SERVICE BULLETIN

N° 109EP-175

DATE: April 26, 2021

**ATA 64 - INSPECTION OF TAIL ROTOR SHAFT ASSY P/N 109-0445-08-(ALL DASHES)
AND TAIL ROTOR SLEEVE ASSY P/N 109-0130-90-117/-121**

Figure 1

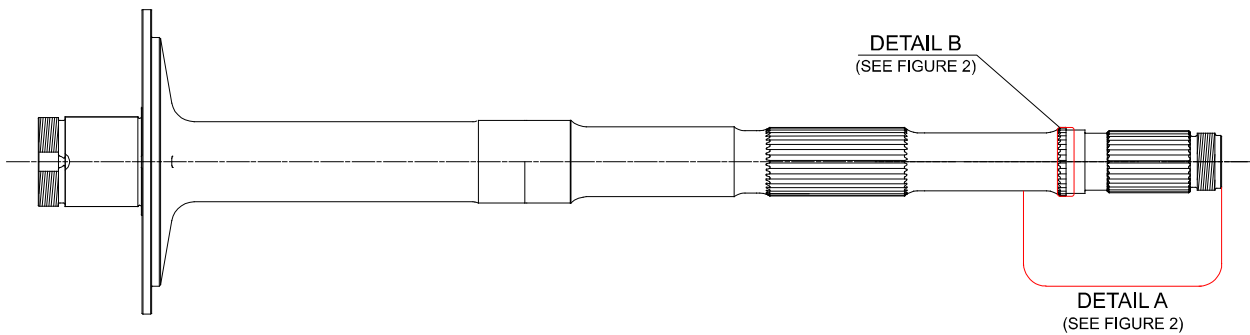
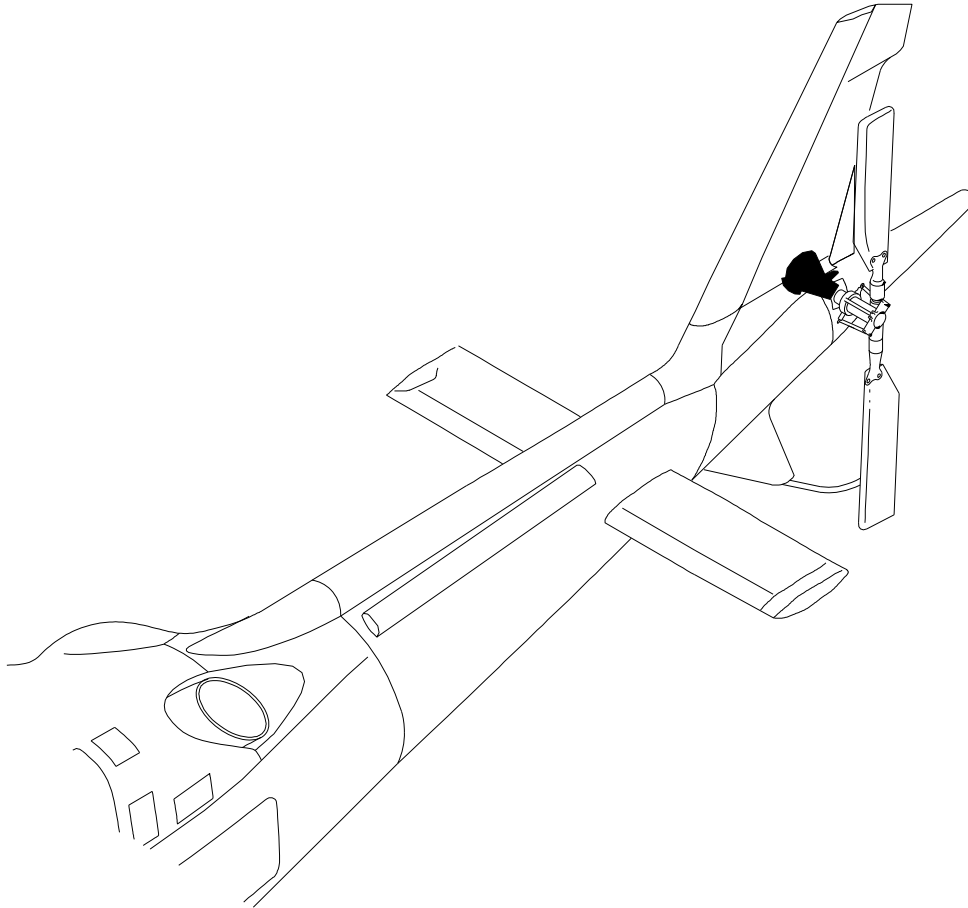
- 6.1 In case anomalies are detected, take pictures of the affected bushing and sleeve, record the findings on the Detailed Inspection Form, and contact Leonardo Helicopters to evaluate part serviceability. If necessary, in accordance with MM Paragraph 64-31-6, replace it with a serviceable TR Sleeve. In the meantime, proceed with step 7.
- 6.2 In case of no findings, proceed to next step.
7. With reference to Figure 1 and Figure 2 detail A, gain access to tail rotor shaft assy P/N 109-0445-08-(all dashes) and:

- 7.1 perform internal surface endoscope inspection for abnormal wear condition, corrosion, fretting, crack and damage;
- 7.2 perform external surface visual inspection for abnormal wear condition, corrosion, fretting, crack and damage;
- 7.3 with reference to Figure 1 and Figure 2 detail B, in accordance with Annex A, perform surface Fluorescent Penetrant Inspection on the indicated area;
- 7.4 if no evidence of existing anomalous wear, corrosion, fretting, damage or crack is found, proceed to step 8;
- 7.5 if evidence of anomalous wear, corrosion, fretting, damage or crack is found, take relevant pictures, record the findings on the Detailed Inspection Form and contact Leonardo Helicopters to evaluate part serviceability. If necessary, in accordance with MM Paragraph 65-21-6, replace it with a serviceable 90-Degree Gearbox.

Figure 2

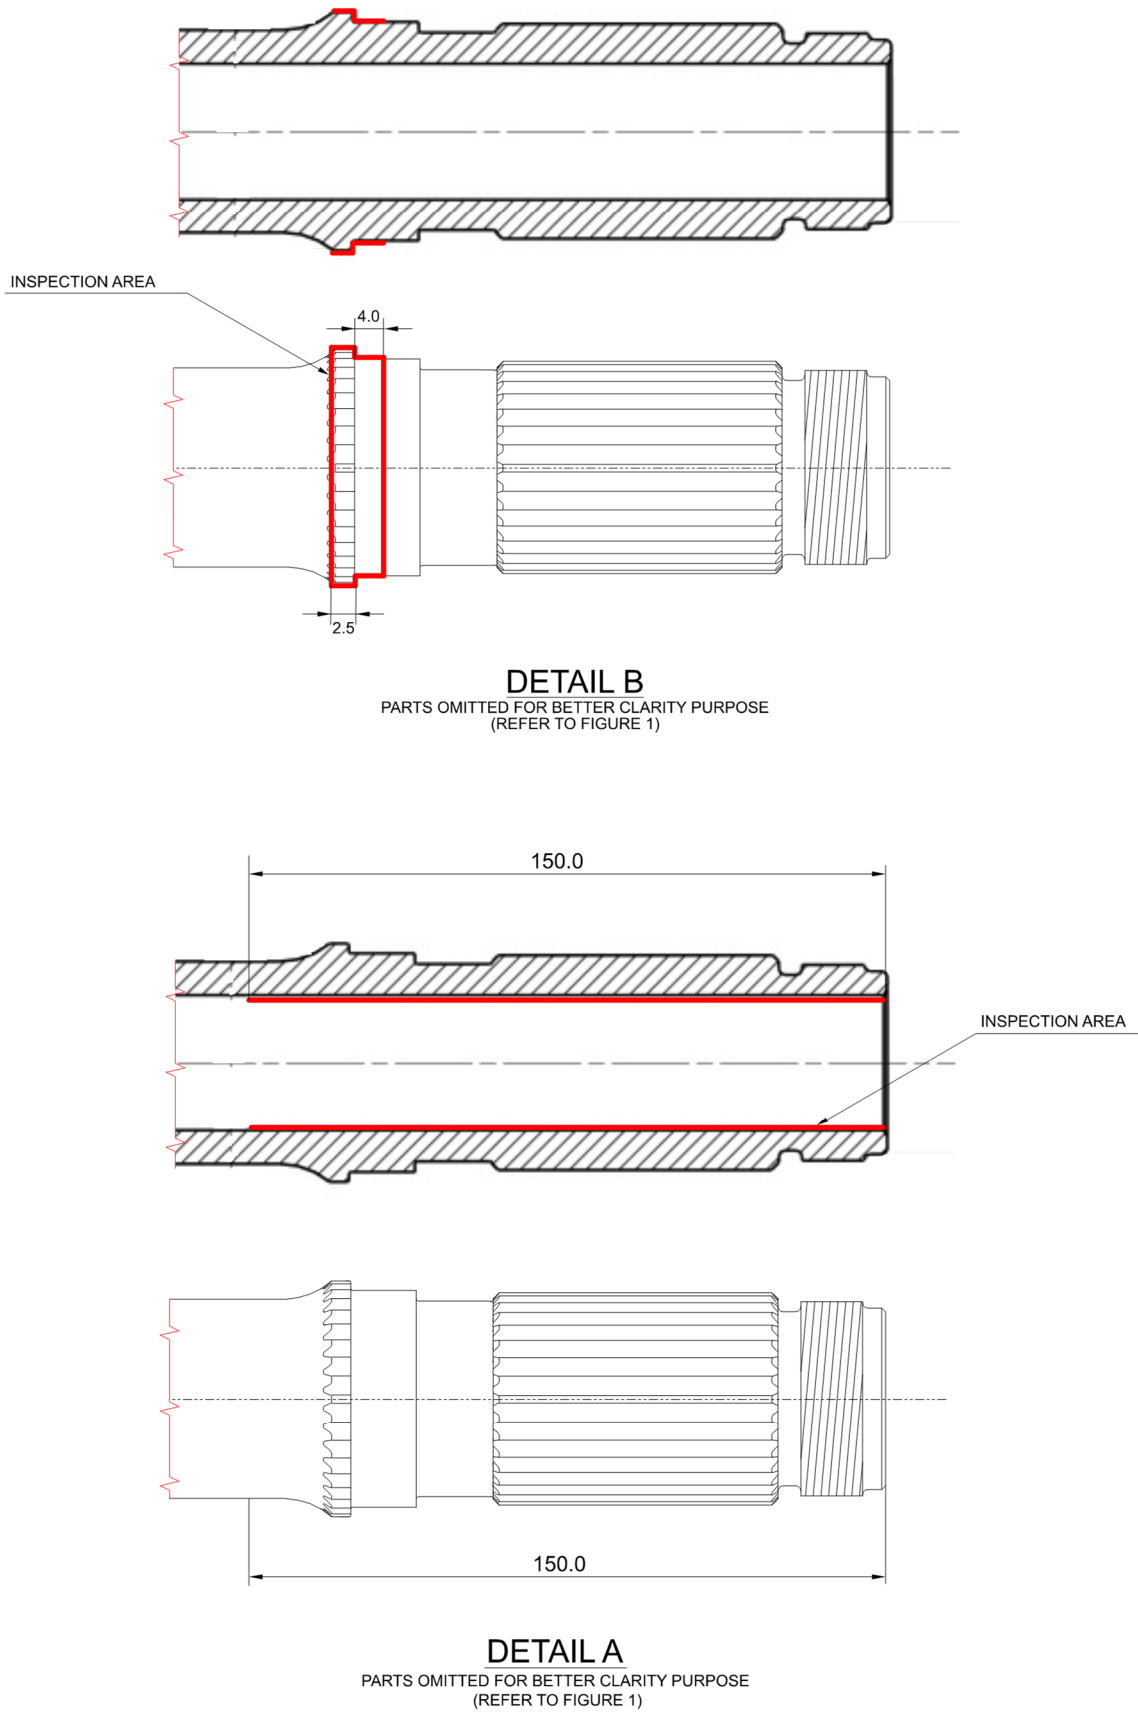
1. During application of tail rotor gearbox 400 FH scheduled inspection, with reference to Figure 2 Detail B, verify the presence of solid film lubricant on “inspection area” (it should be present only on the “4.0mm section” and on vertical side of shoulder). If necessary, restore the layer of solid film lubricant MIL-L-23398 Type IV as follows:
 - 1.1 Mask off surrounding areas near the inspection zone (Figure 2, Detail B) with adhesive Aluminium tape.
 - 1.2 Clean the part with a clean cloth soaked with Class 2 solvent listed in QPL-AMS-2644.
 - 1.3 In accordance with CPCP 20-70-10, touch up where necessary with solid film lubricant with MIL-L-23398 Type IV product.
2. Record for compliance with Part IV of this Service Bulletin on the helicopter logbook.
3. Send the attached compliance form to the following mail box:

Mask off surrounding areas near the inspection zone (Figure 2, Detail B) with adhesive Aluminium tape and remove dry film lubricant using both MEK and plastic bristled brush taking care to the area of the shoulder and related fillet radius.

After the solvent (MEK) is completely evaporated, apply Type 1, Method C, Sensitivity Level 2 liquid penetrant listed in QPL-AMS-2644 using a small soft clean dry brush. Take care to cover all the inspection area (Figure 2, Detail B). Penetrant Dwell Time shall be a minimum of 30 minutes and no more than 60 minutes.

Figure 3

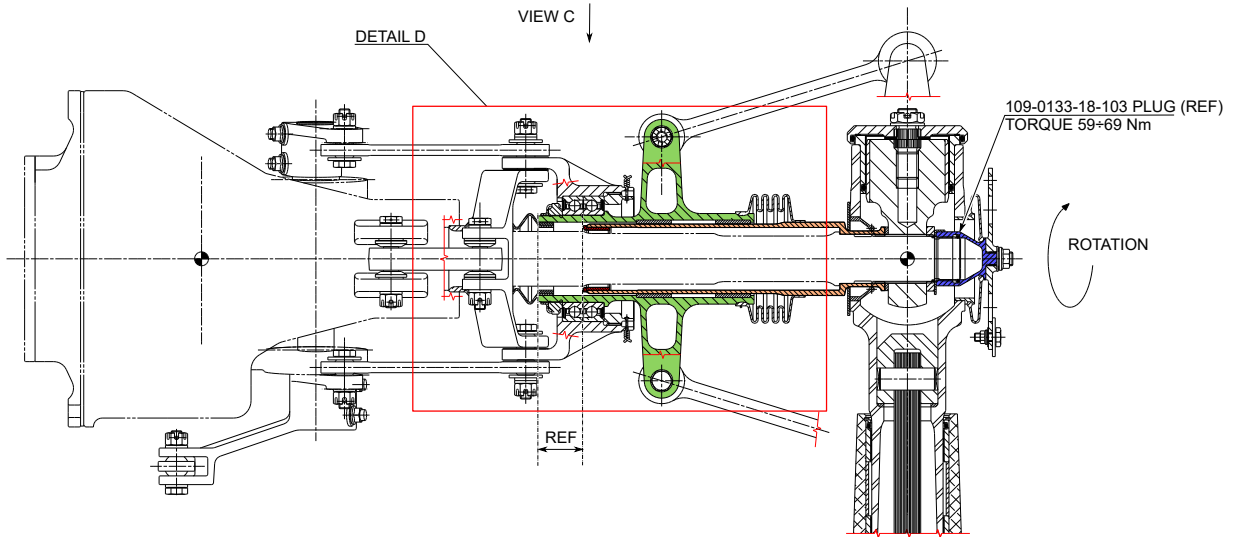
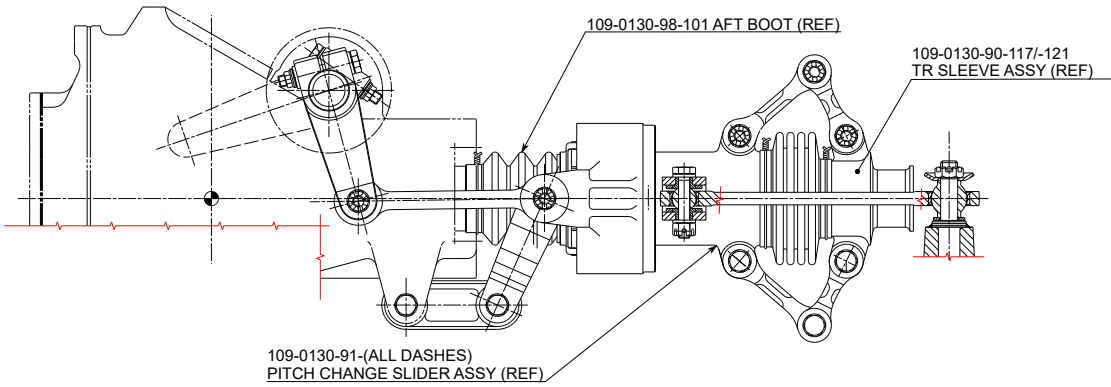
- 11.3 If gap is present between the vertical leg of the tool and the pitch change slider assy, start trimming the short segment until gap is removed.
 - 11.4 Record the dimension of the tool and retain it for Part II inspection.
12. With reference to Figure 3, attach aft boot P/N 109-0130-96-101 on pitch change slider assy.
13. Return the anti torque pedal to center. In accordance with MM Paragraph 00-10-10, disconnect the hydraulic test bench from the helicopter.
14. Return the helicopter to a ready to flight condition and record for compliance with Part I of this Service Bulletin on the helicopter logbook.

3. With reference to Figure 3, detach aft boot from pitch change slider assy.
4. With reference to Figure 4, move aft boot and, using bushing displacement measuring tool, verify that the distance from bushing to pitch change slider assy has not changed since last inspection. If the distance decreases (long side of tool not in contact with slider assy, ref. Figure 4 Detail E), proceed as follows, otherwise proceed to step 5:

- 4.3 In accordance with Figure 3, verify that plug P/N 109-0133-18-103 (or P/N 109-0130-85-1) is torqued at 59÷69 Nm.
 - 4.4 Record the torque value on the Detailed Inspection Form and proceed with next step.

- 4.9 In accordance with MM Paragraph 64-00-14 or 64A-00-13, re-install previously removed tail rotor hub and blade assy. Proceed to step 7.
- 5. With reference to Figure 3, attach aft boot P/N 109-0130-96-101 on pitch change slider assy.

Figure 4

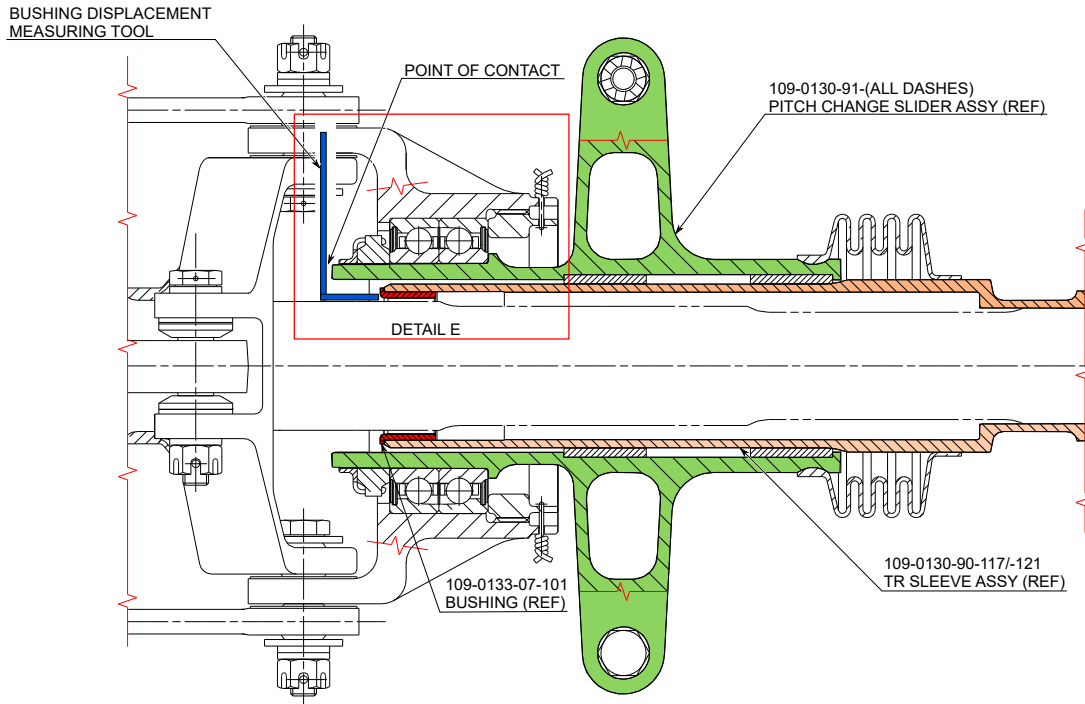
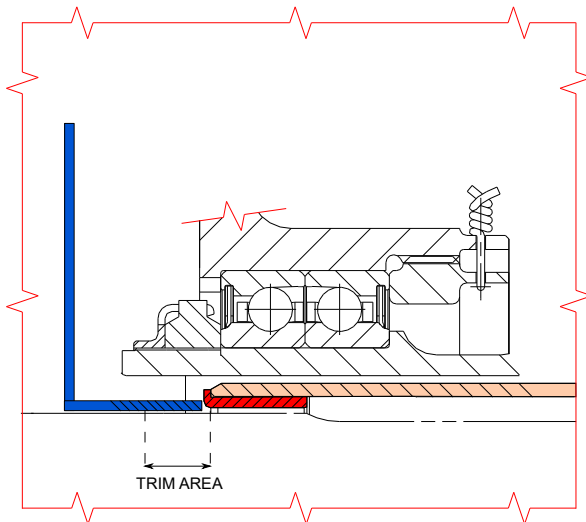
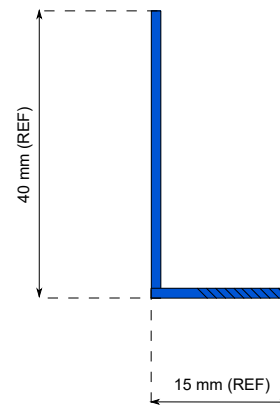
11. In accordance with Figure 4, manufacture on site the bushing displacement measuring tool following the next steps:
 - 11.1 Starting from a metal sheet of 55x5 mm (1 mm thickness), bend it to obtain an “L” shape with the size indicated in Figure 4.
 - 11.2 In accordance with Figure 4 Detail E, insert the tool between pitch change slider assy and tail rotor shaft assy until reaching the bushing of the TR sleeve assy.

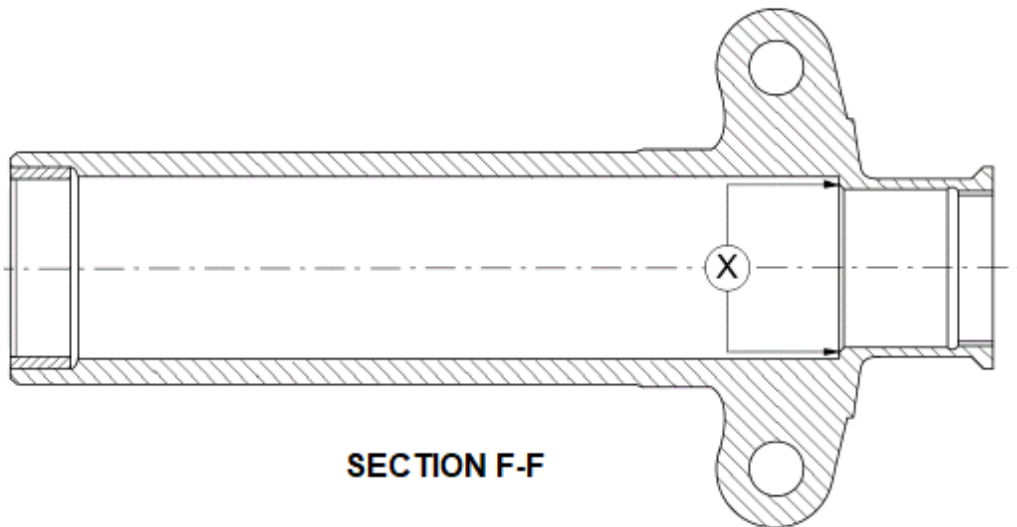
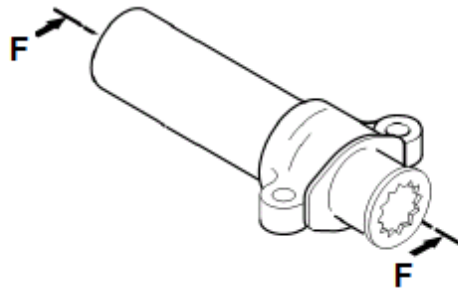
- 3.4 With reference to Figure B1, Detail F, examine the mating surface between the sleeve and the tail rotor shaft assy (X Area), for wear and stepping. No wear or stepping is permitted. In case of any doubt, clean with the cleaning solvent MIL-PRF-680, Type II and perform again the inspection. If the presence of damage is confirmed, replace the sleeve.
